SYDNEY METRO CITY & SOUTH WEST
CONSTRUCTION TRAFFIC MANAGEMENT PLAN
CROWS NEST SITES
 APRIL 2017

CTMP Review Comments Sheet

DRAWING No:	DD-SYDM-DWG-0003-10	
SHEET	1	OF 2
REVISION	A-00

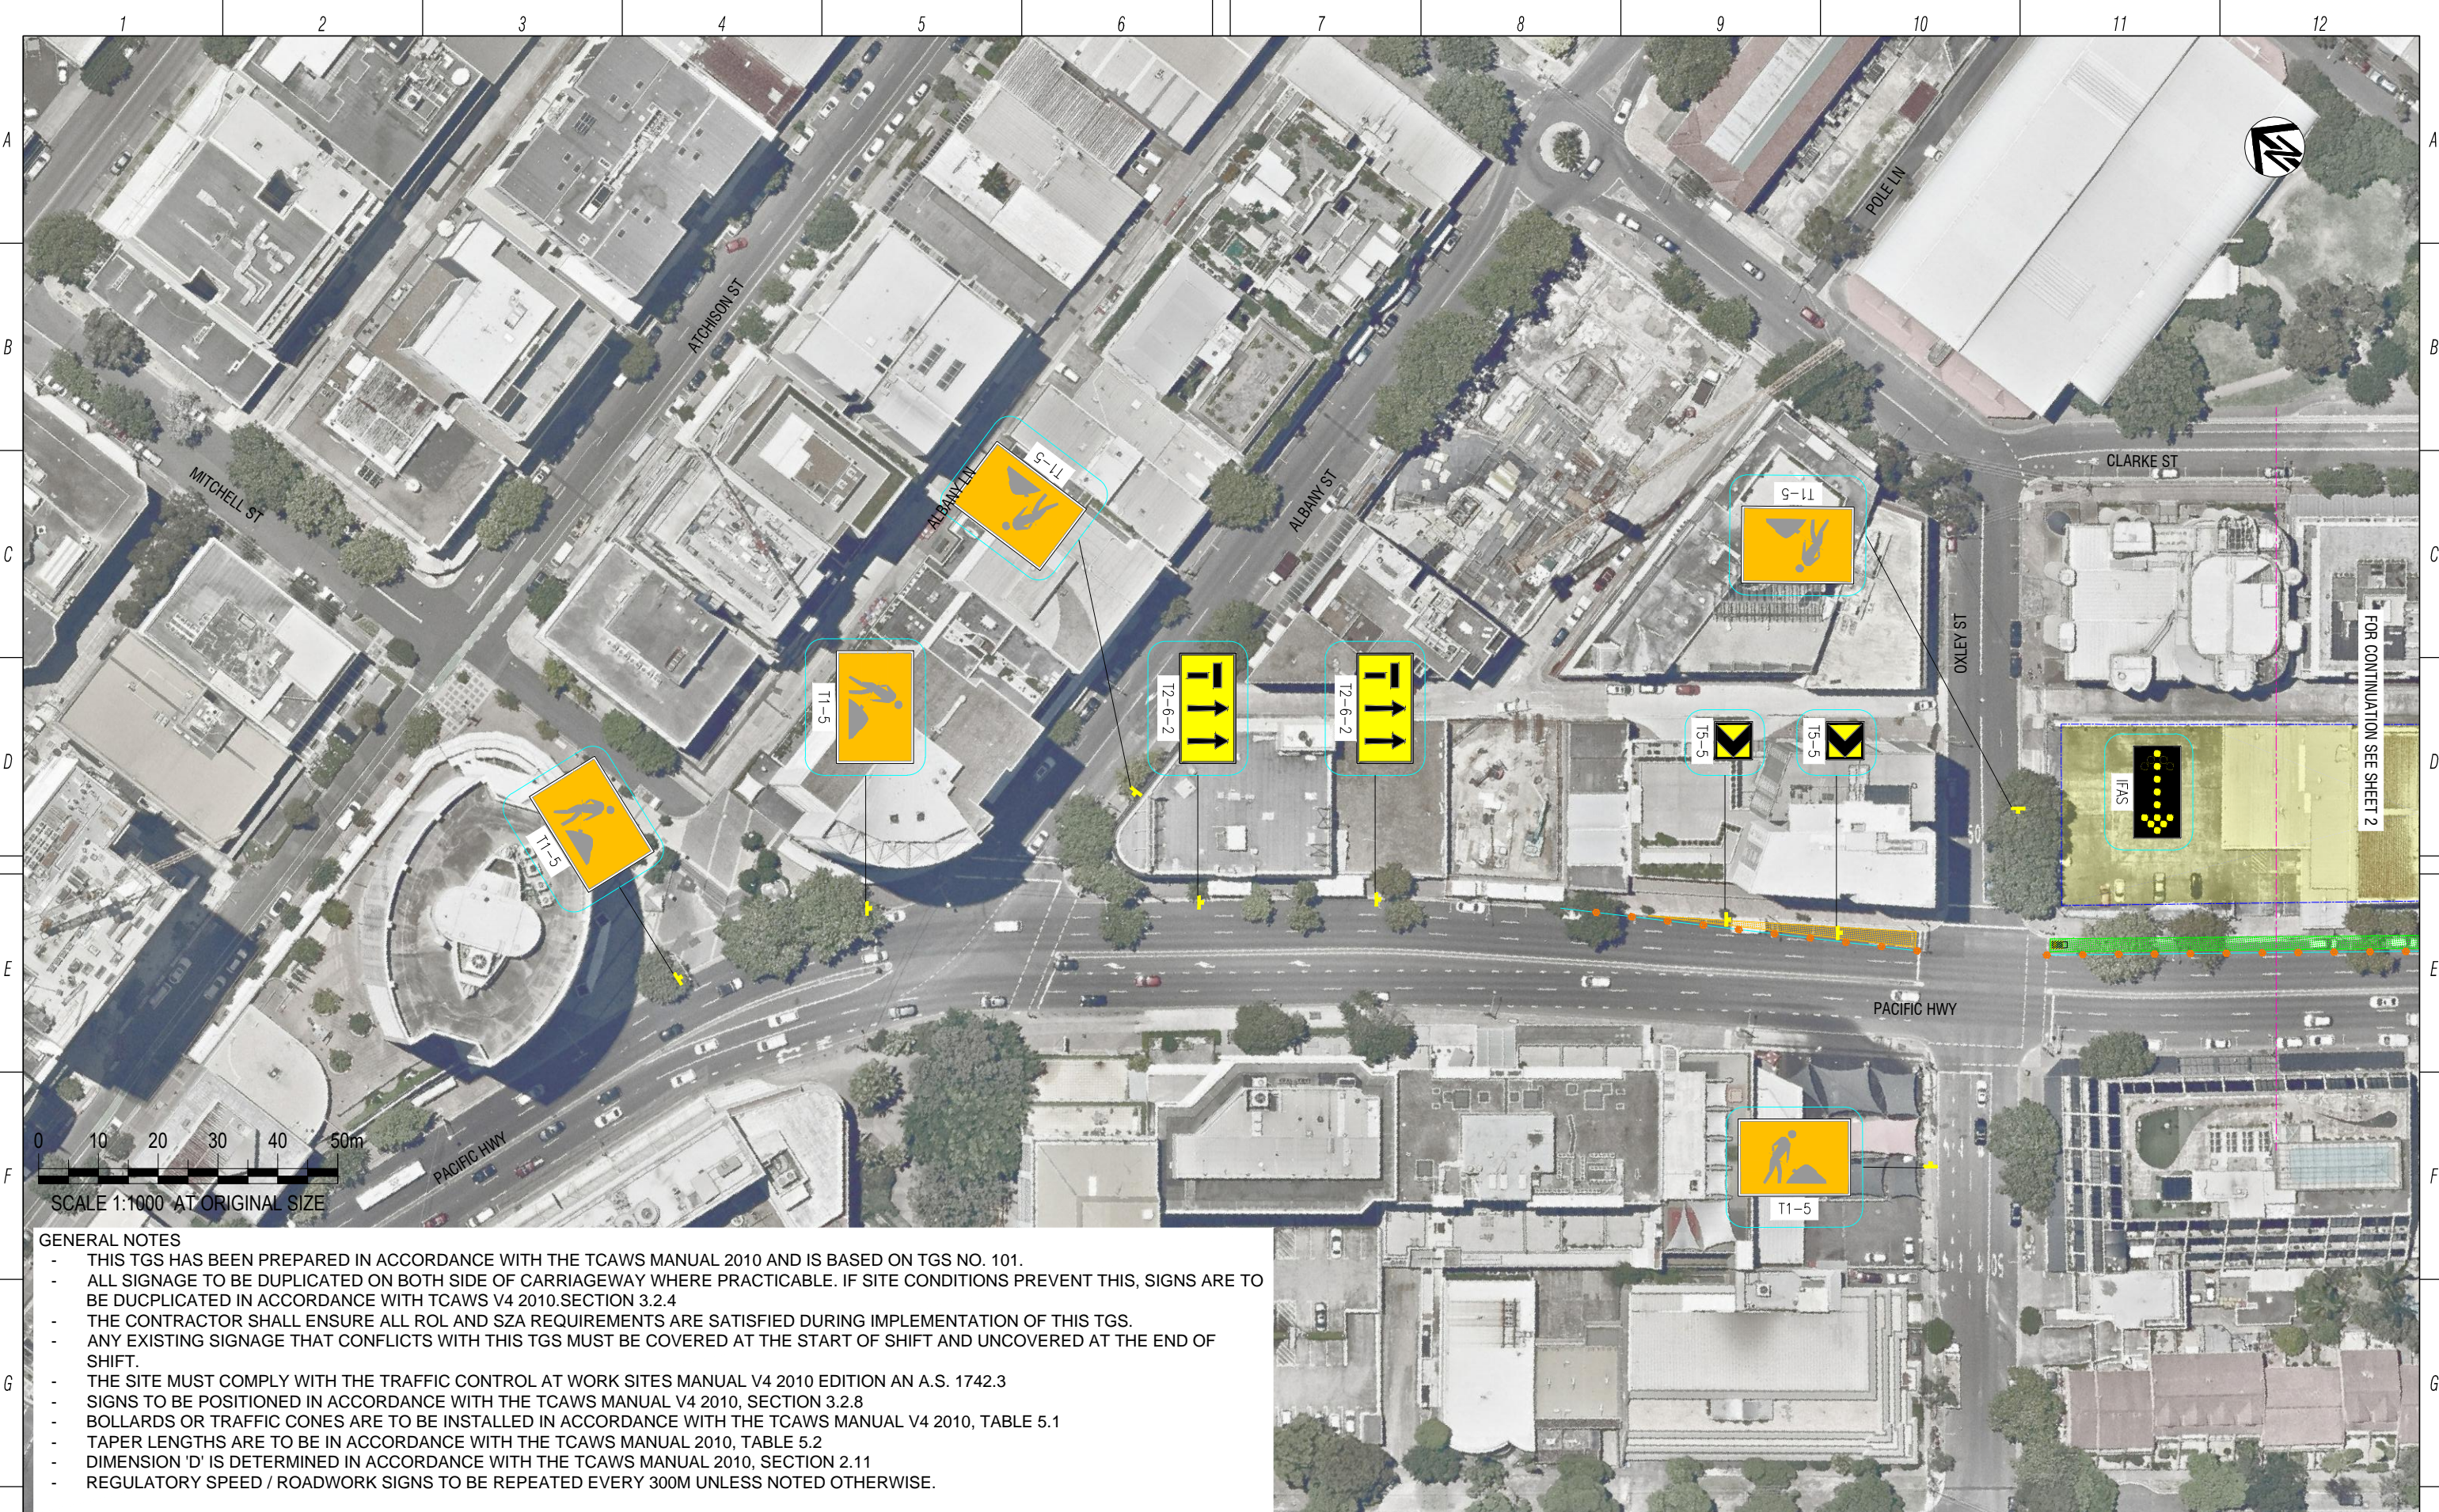
4.	Appendix 3: Plan 0003-10 sheet 1: the flashing arrow is (presumably) on the departure side of the intersection. It's considered that this will be more effective on the approach side. This also applies to sheet 0003-11	Consider relocating.	Reject	The flashing arrow is also used to forewarn motorists turning out from the side streets of the lane closures in place

5.	Appendix 3: Plan 0003-10 sheet 1: It's unclear where the flashing arrow is to be located and which way it's facing, and why.	Clarify.	Reject	Refer to Item 4 response

DRAWING No:	DD-SYDM-TYP-0000-02	
SHEET	1	OF 1
REVISION	A-00

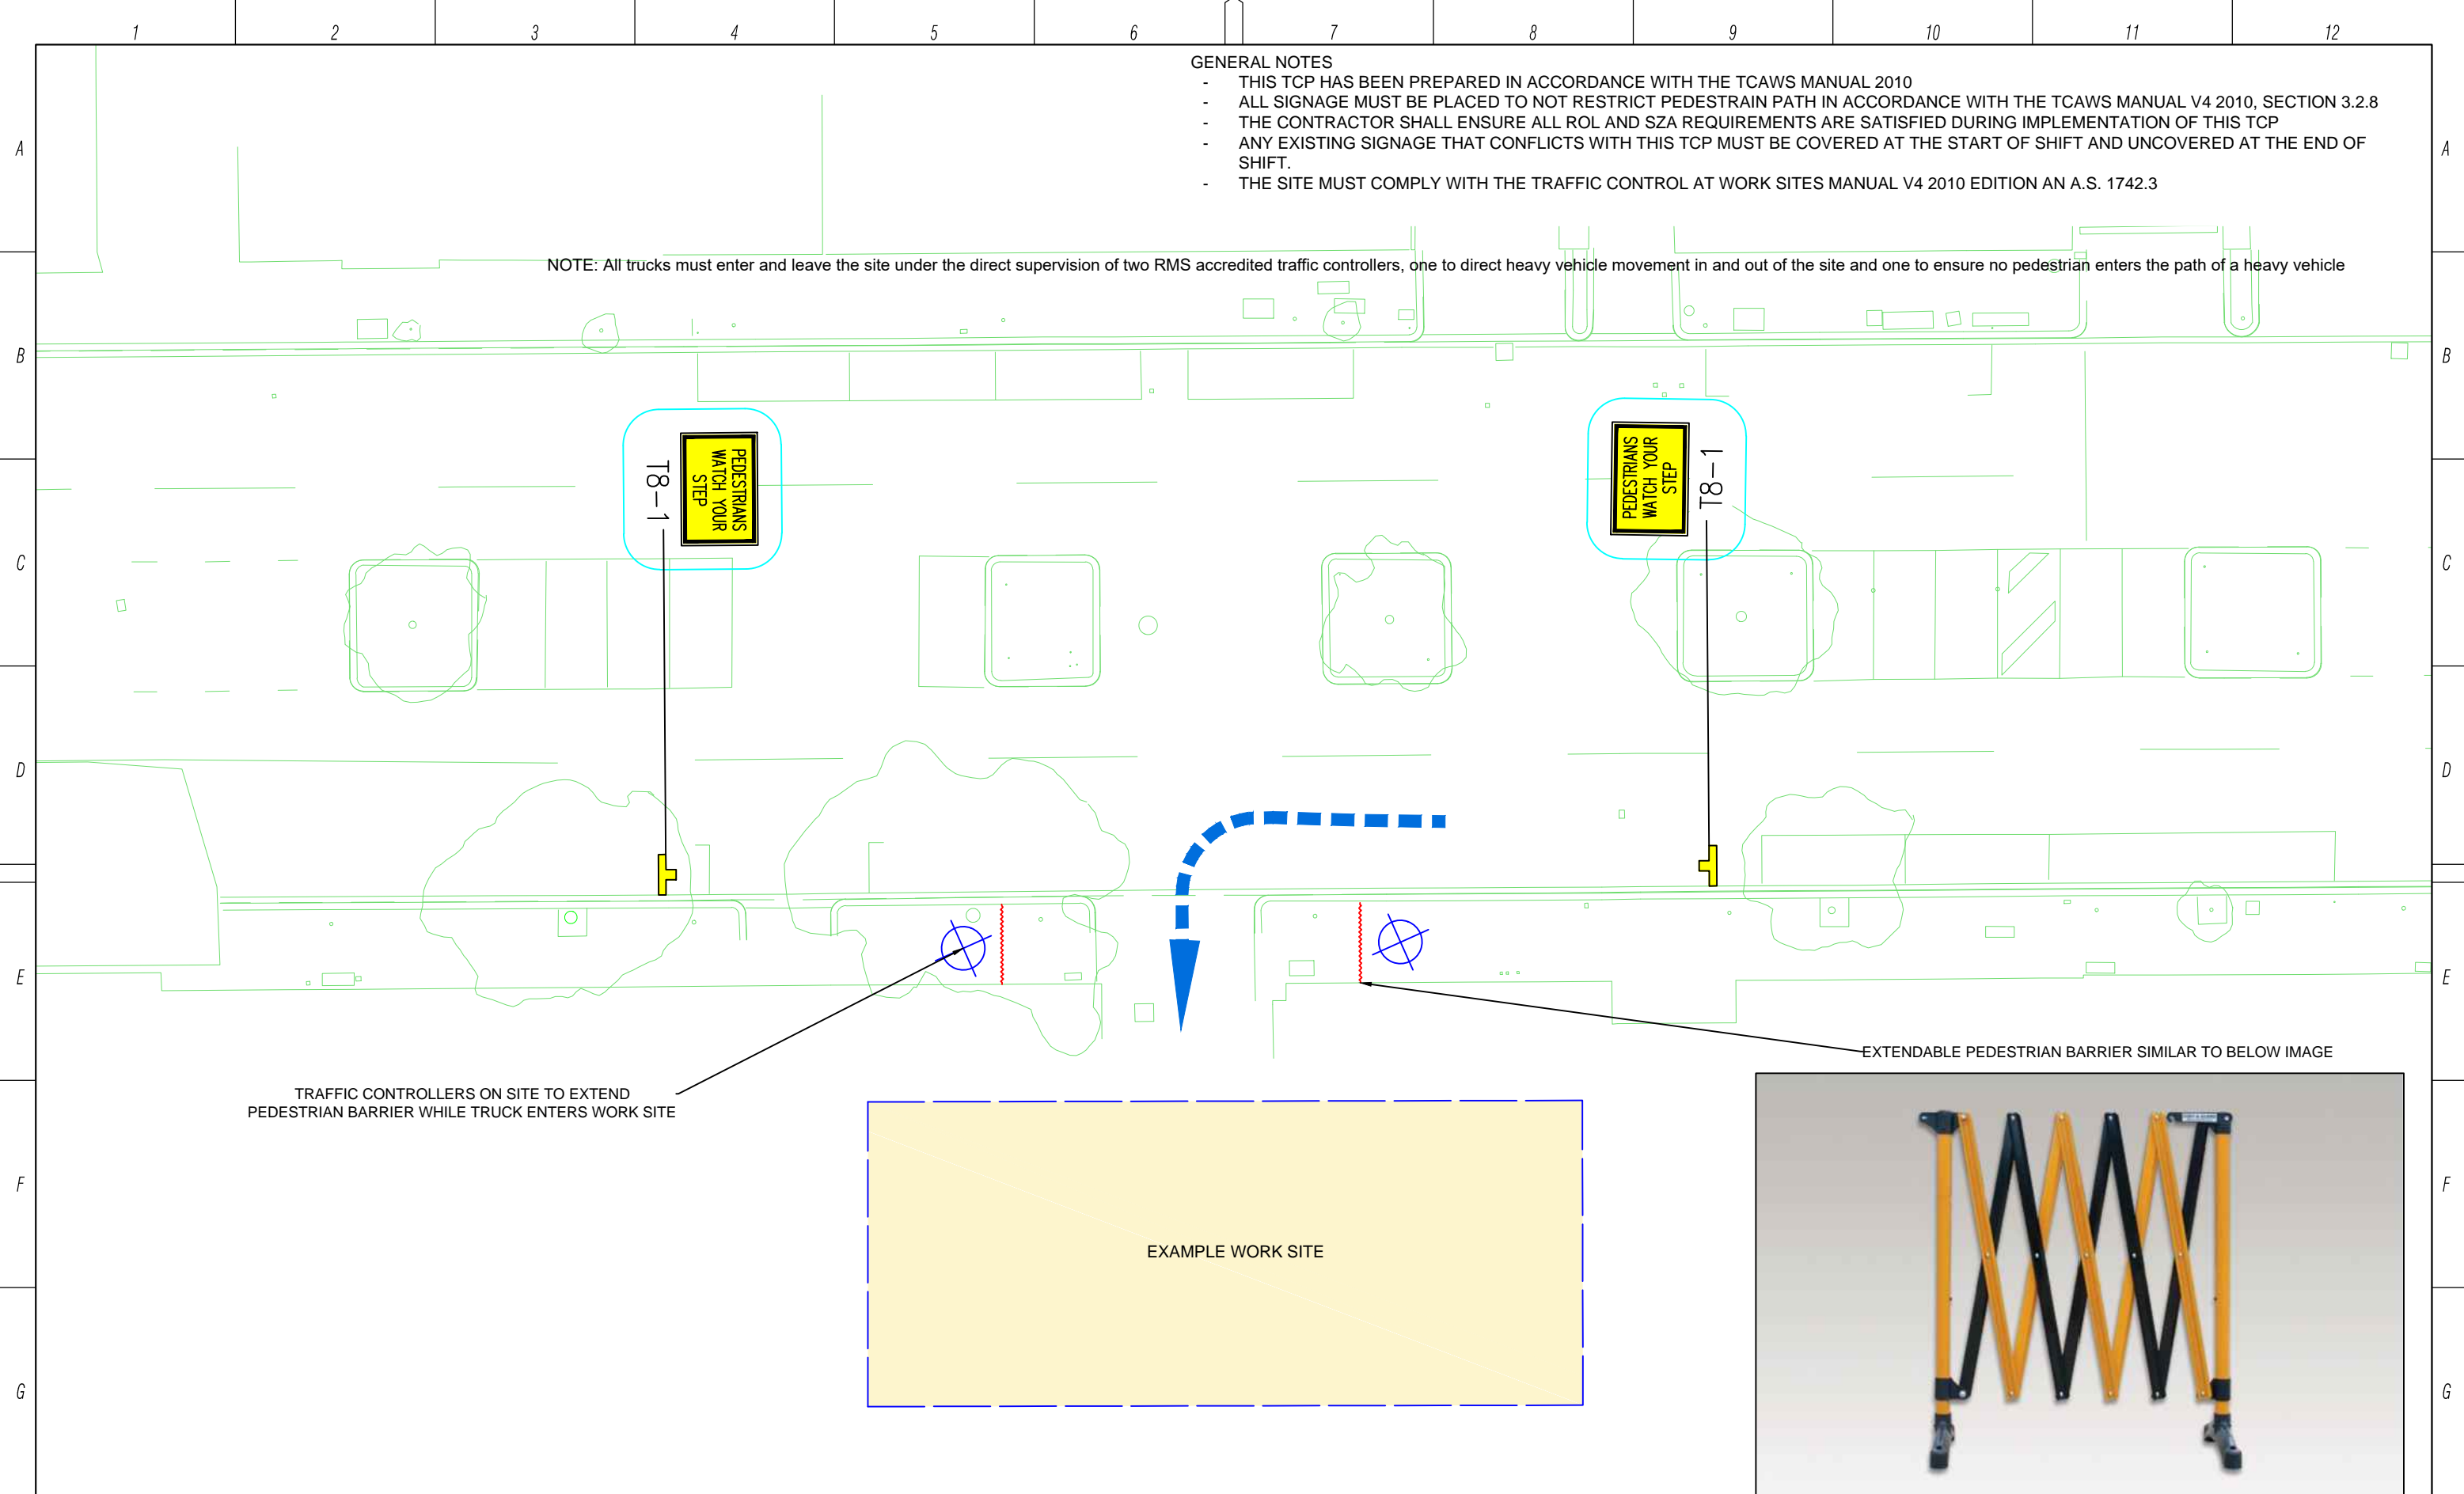
Item	Section/ Page	Comments	Response
13	Appendix 3 Drawing DD-SYDM-DWG-0003-09	An additional traffic controller should be added to the TCP on Clarke Street south of Clarke Lane to ensure no pedestrians enter the path of the heavy vehicle.	Drawing now removed
14	Appendix 3 Drawing DD-SYDM-DWG-0003-10	Slow lane closure on Pacific Highway. What activities is this TCP required for? Is this only for hoarding installation?	Document amended
15	Appendix 3 Drawing DD-SYDM-DWG-0003-11	Slow lane closure on Hume Street. What activities is this TCP required for? Is this only for hoarding installation?	Document amended
16	Appendix 3 Drawing DD-SYDM-TYP-0000-02	All trucks must enter and leave the site under the direct supervision of two RMS accredited traffic controllers, one to direct heavy vehicle movement in and out of the site and one to ensure no pedestrian enters the path of a heavy vehicle.	Noted and drawing amended with note
